The Commission has issued the enclosed Amendment No. to Provisional Operating License No. DPR-19 for Dresden Station Unit 2 and Amendment Nos. and to Facility Operating License Nos. DPR-29 and DPR-30 for Quad Cities Station Units 1 and 2, respectively. The amendments are in response to your letter of March 19, 1980.

The amendments establish MAPLHGR limits for standard 8x8 (8D250 and 8D262) fuel types for exposure values beyond those currently given in the Technical Specifications.

AMENDMENT TO PROVISIONAL OPERATING LICENSE

SAFETY EVALUATION BY THE OFFICE OF NUCLEAR REACTOR REGULATION
SUPPORTING AMENDMENT NO. 50 TO PROVISIONAL OPERATING LICENSE NO. DPR-19,
AMENDMENT NO. 59 TO FACILITY OPERATING LICENSE NO. DPR-29, AND
AMENDMENT NO. 54 TO FACILITY OPERATING LICENSE NO. DPR-30

Figure 3.5-1 Maximum Average Planar Linear Heat Generation Rate (MAPLHR) vs. Planar Average Exposure (Sheet 2 of 3)

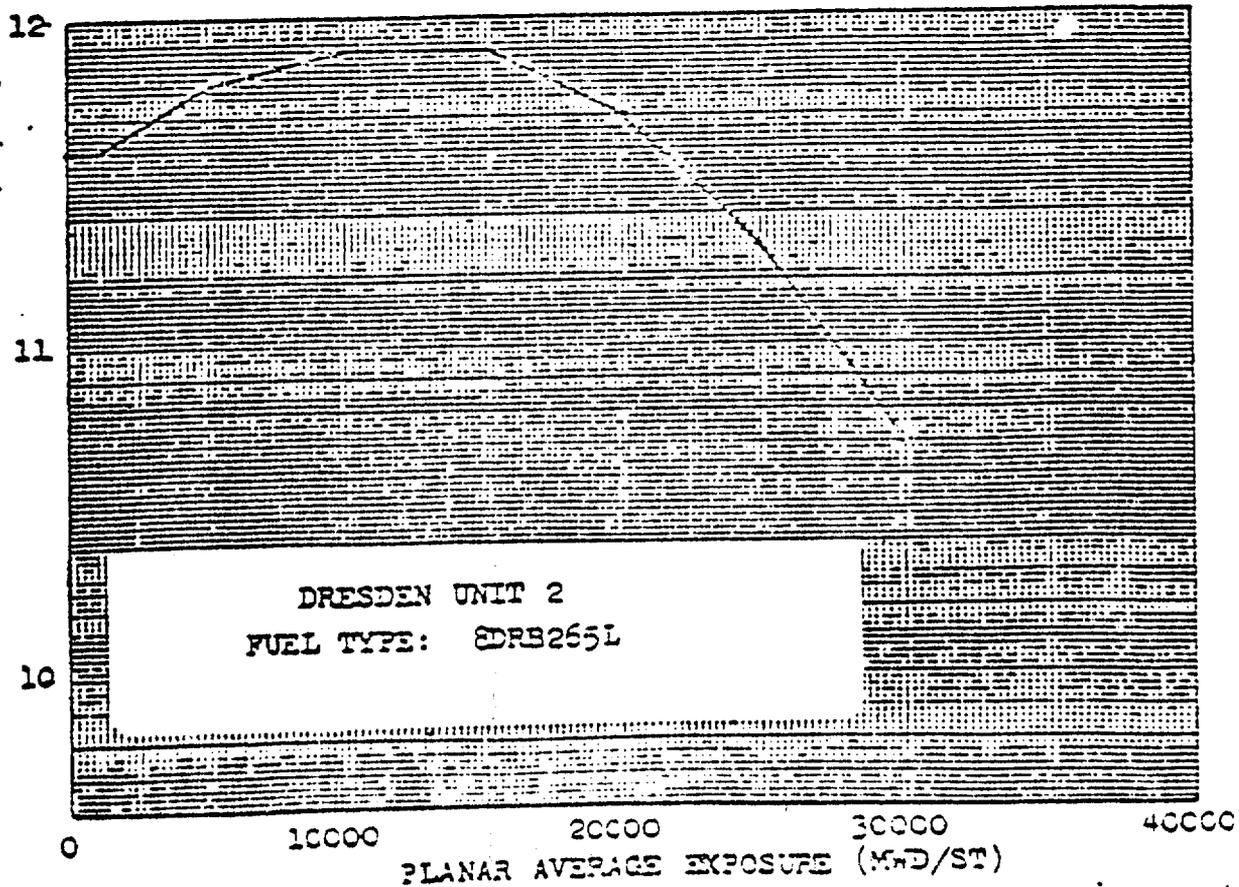
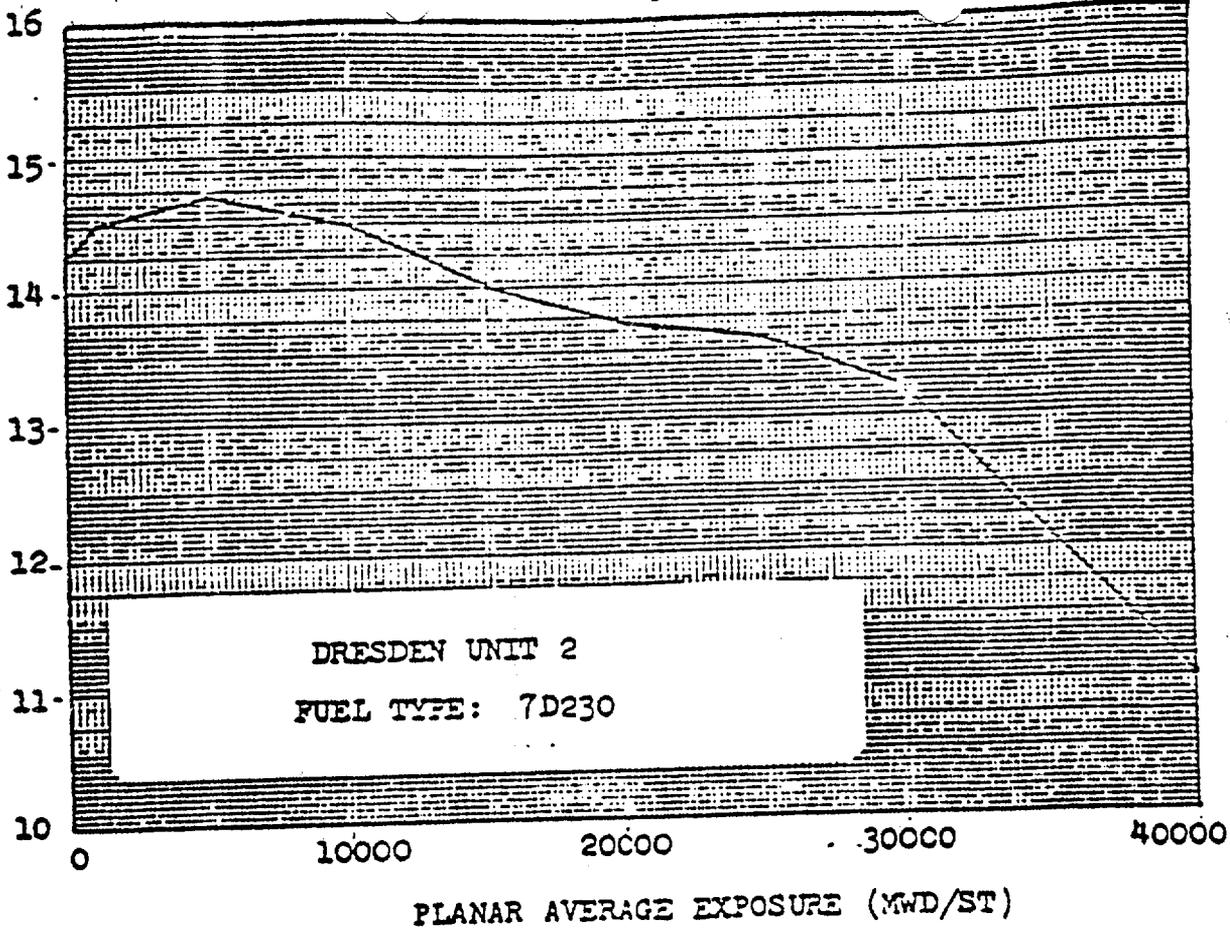
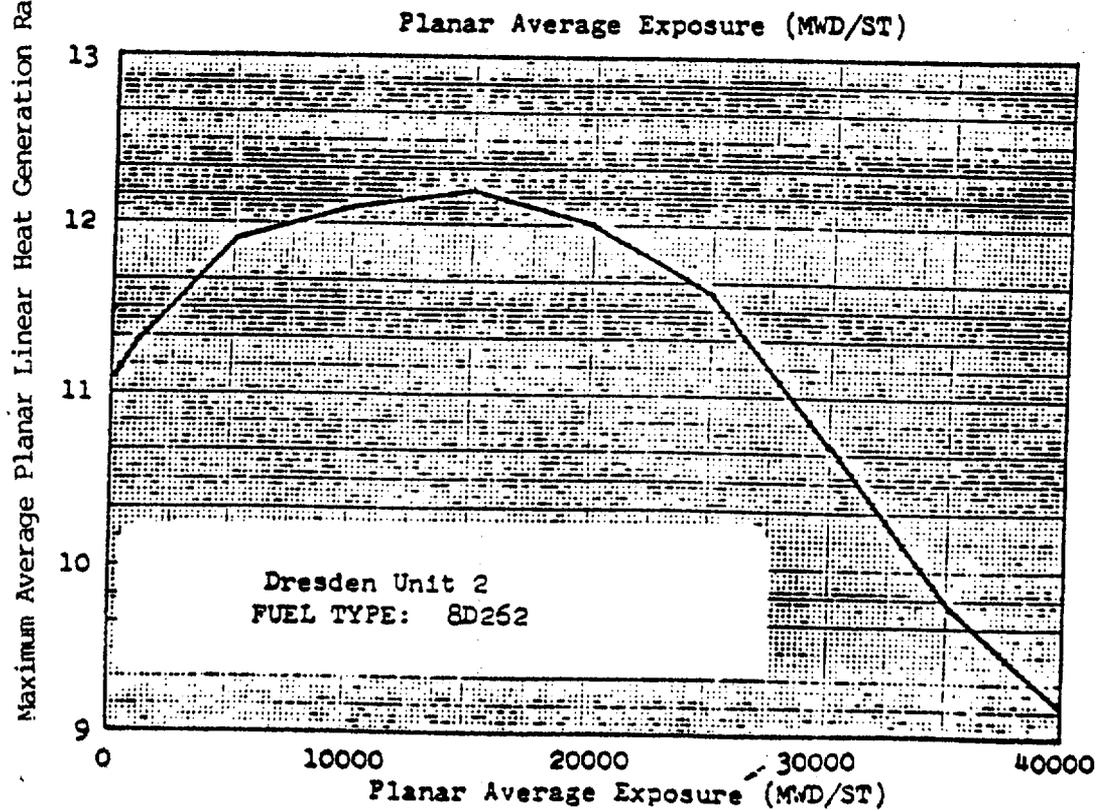
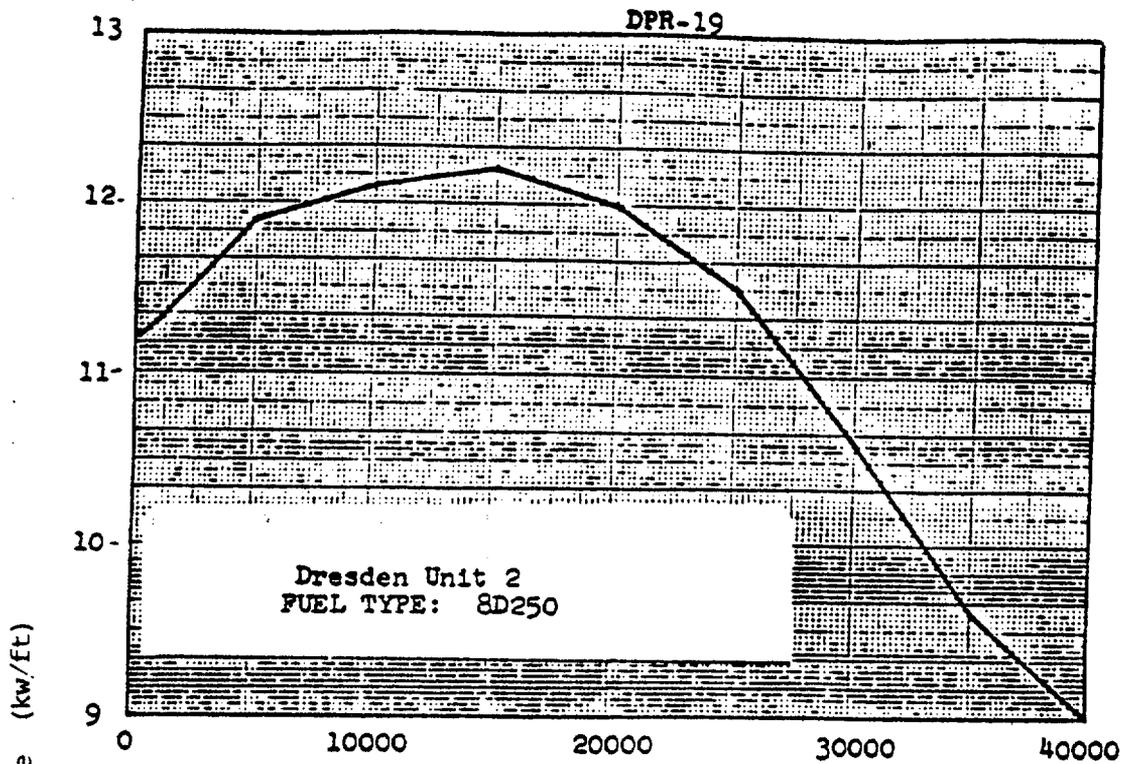
Revise the Appendix "A" Technical Specifications as follows:

During steady state power operation, the average linear heat generation rate (LHGR) of all the rods in any fuel assembly, as a function of average planar exposure, at any axial location, shall not exceed the maximum average planar LHGR shown in
